RE: Modifications to Niagara Region Wind Farm (Addendum 2)

The addendum report proposes relocation (<10m shift from original proposed location) of turbines 18, 32 and 35. Upon review of the addendum report, MNR is satisfied that the Natural Heritage Assessment requirements of Ontario Regulation 359/09 have been met.

Reference: Niagara Region Wind Farm NHA/EIS Addendum for Relocating Turbines T18, T32 and T35

Figure No.
2.32

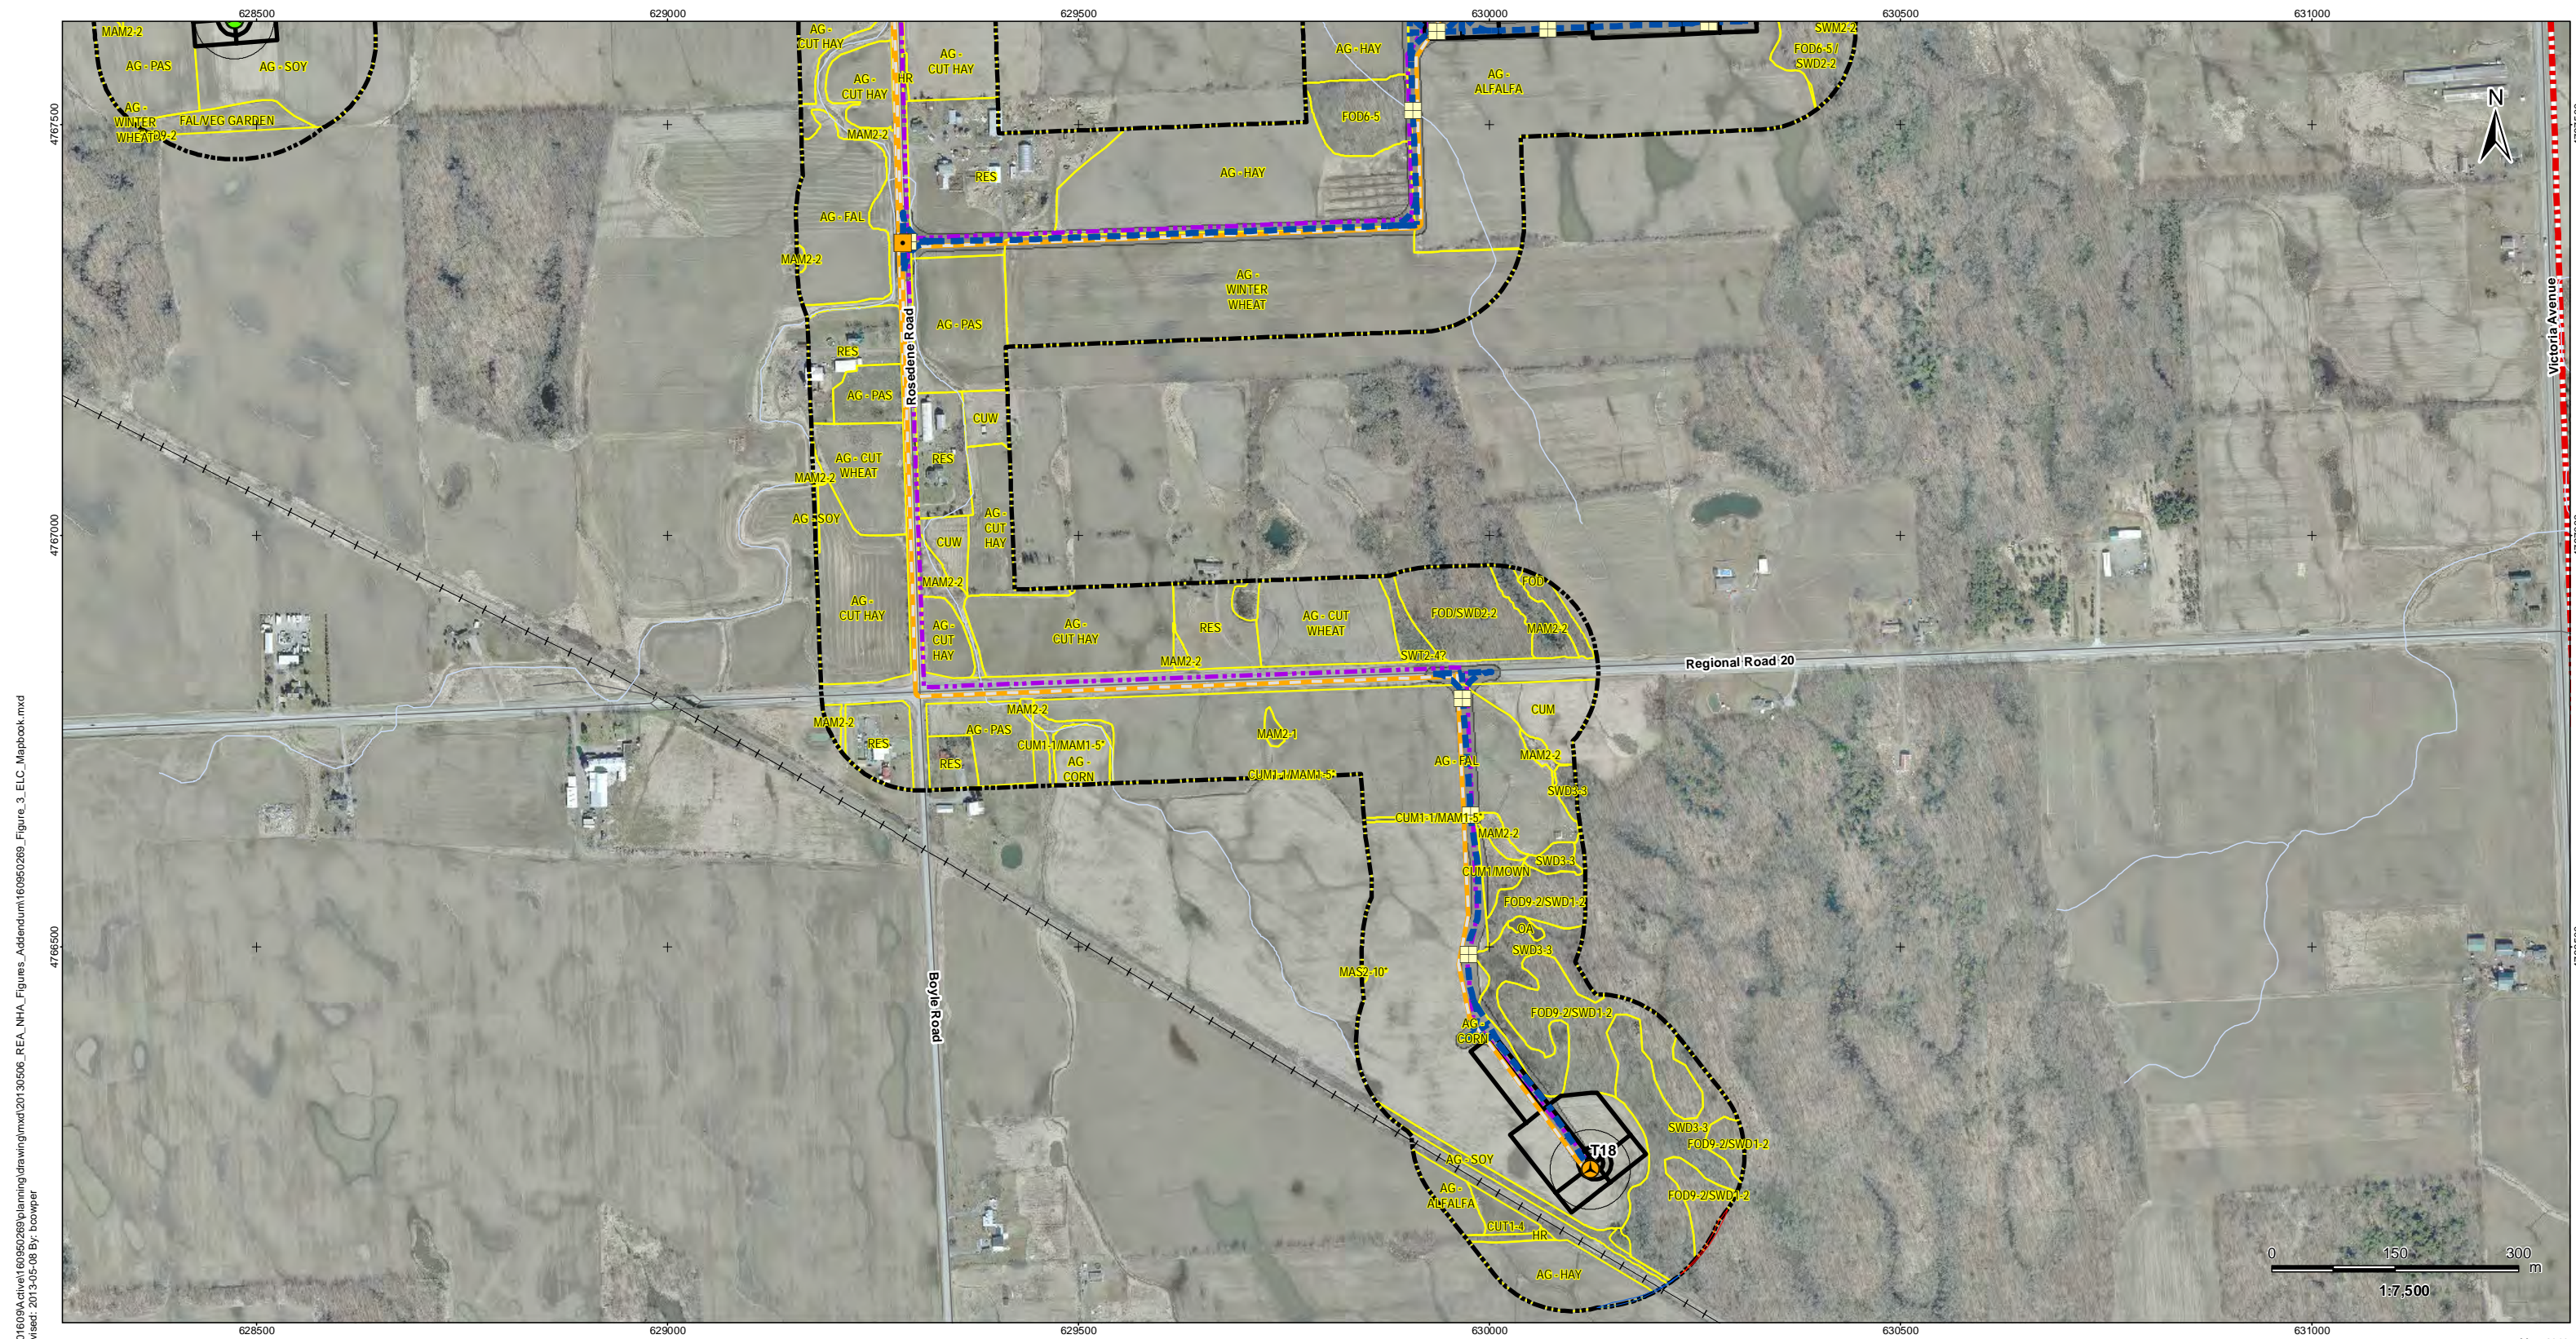
The NHA identified portions of an unevaluated wetland identified by the NPCA within the original zone of investigation. The expanded zone of investigation consists of an agricultural field. No additional natural heritage features were identified as part of the Records Review within the revised zone of investigation (revised **Figures 2.32**).

Figure No.
6.17

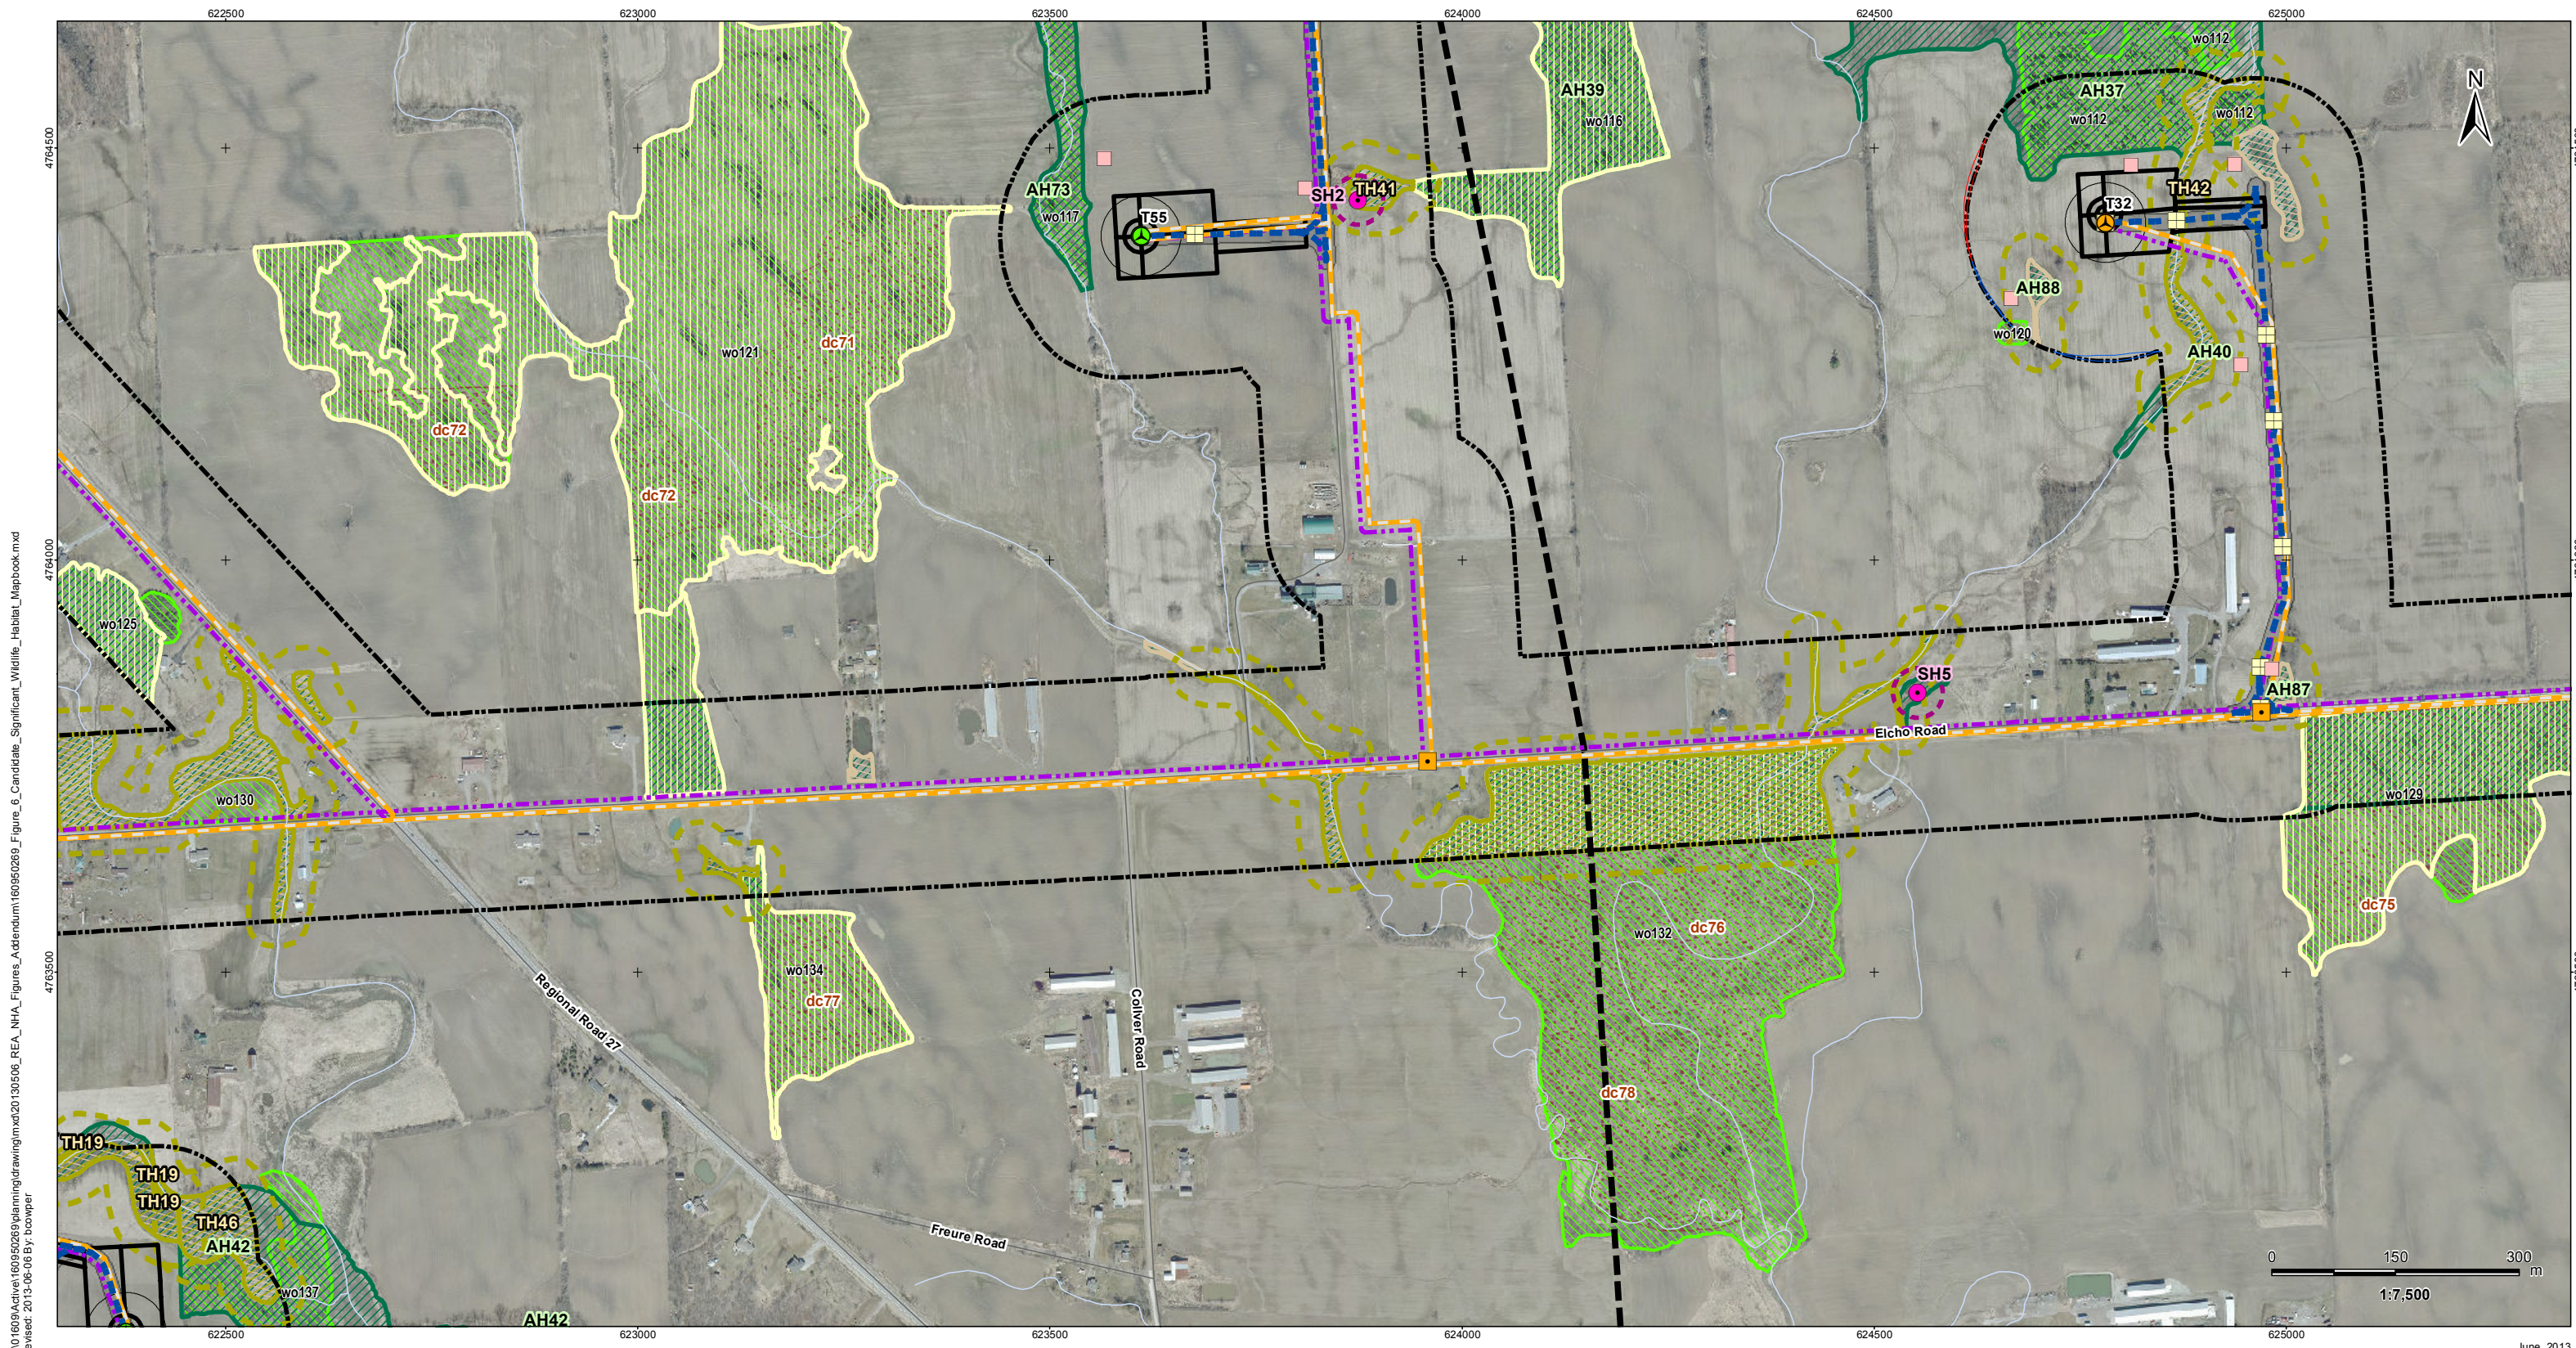
Portions of the Highway 20 and 24 Provincially Significant Wetland Complex (we220) and associated woodland (wo97) were confirmed during site investigations to be present within the zone of investigation. Candidate significant wildlife habitat features within the zone of investigation include amphibian habitat (ah29), a deer congregation area (dc58), winter raptor habitat (wr6), woodland vole habitat, woodland raptor nesting habitat and woodland area sensitive bird breeding habitat. No additional candidate significant wildlife habitat features were identified as occurring within the expanded zone of investigation (Revised **Figure 6.17**).

Figure No.
6.29

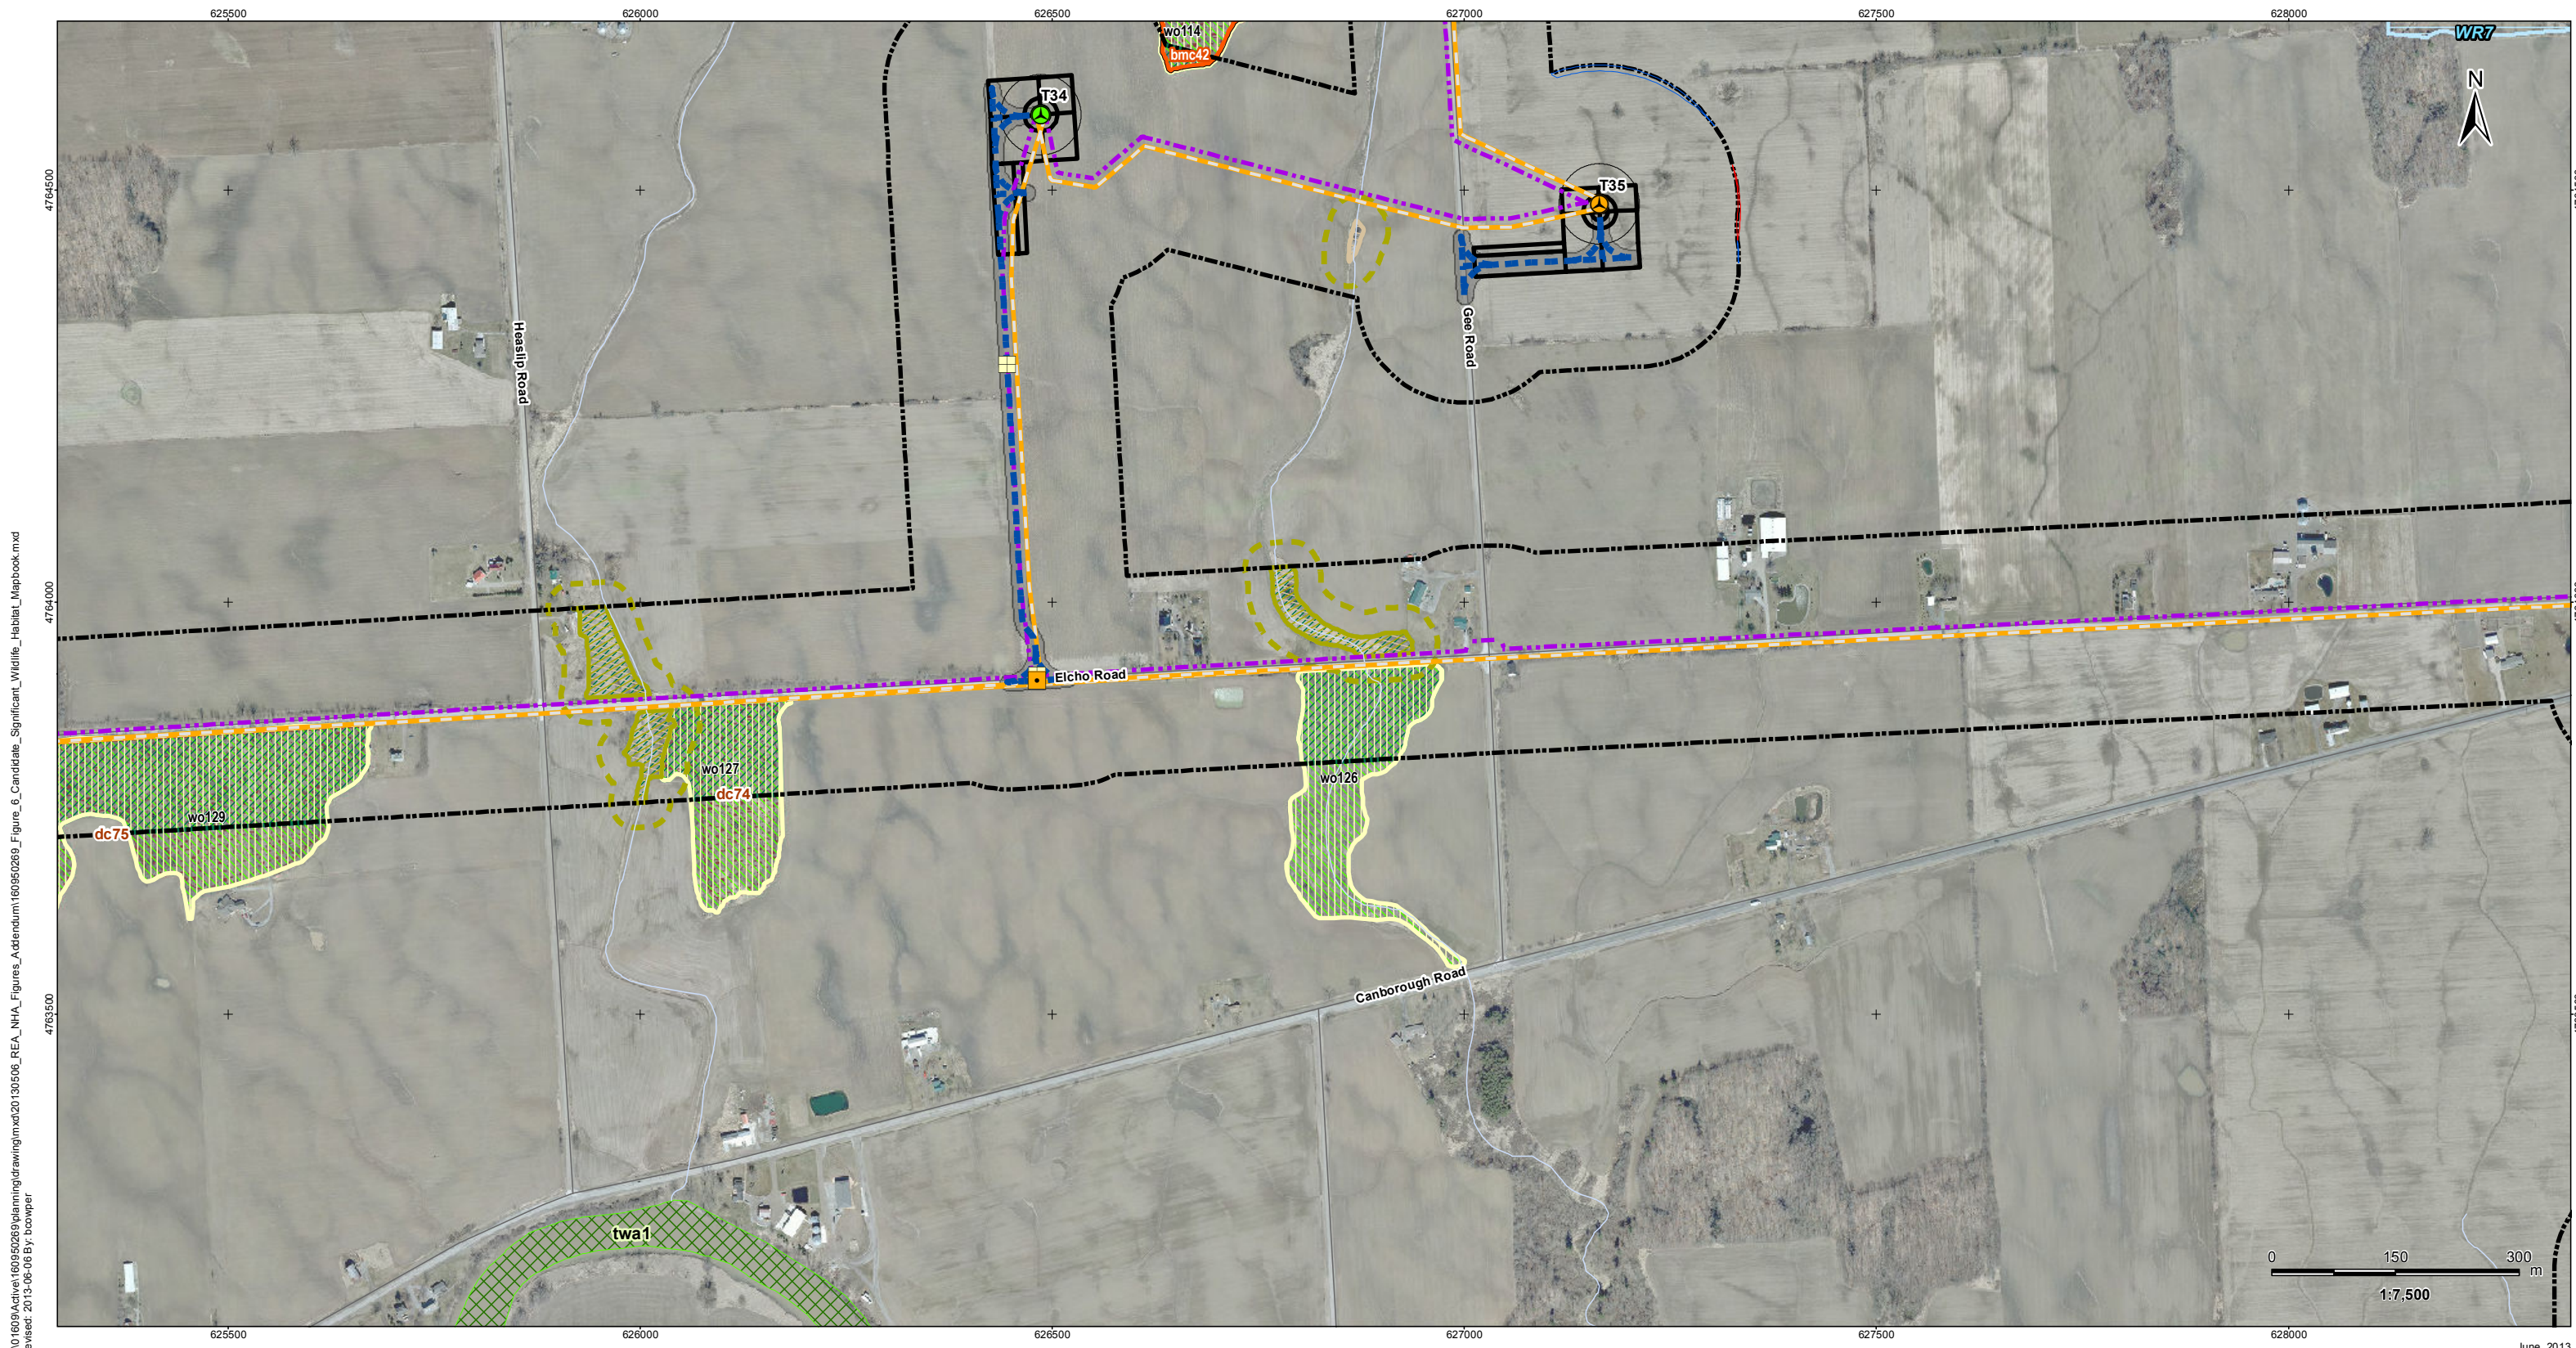
Portions of the Beaver Creek Provincially Significant Wetland Complex (we282), an unevaluated wetland (we292) and woodland (wo112 and wo120) were confirmed during site investigations to be present within the zone of investigation. Candidate significant wildlife habitat features within the zone of investigation include amphibian habitat (ah37, ah40, ah88), turtle nesting habitat (th42) and terrestrial crayfish habitat. No additional candidate significant wildlife habitat features were identified as occurring within the expanded zone of investigation (Revised **Figure 6.29**).
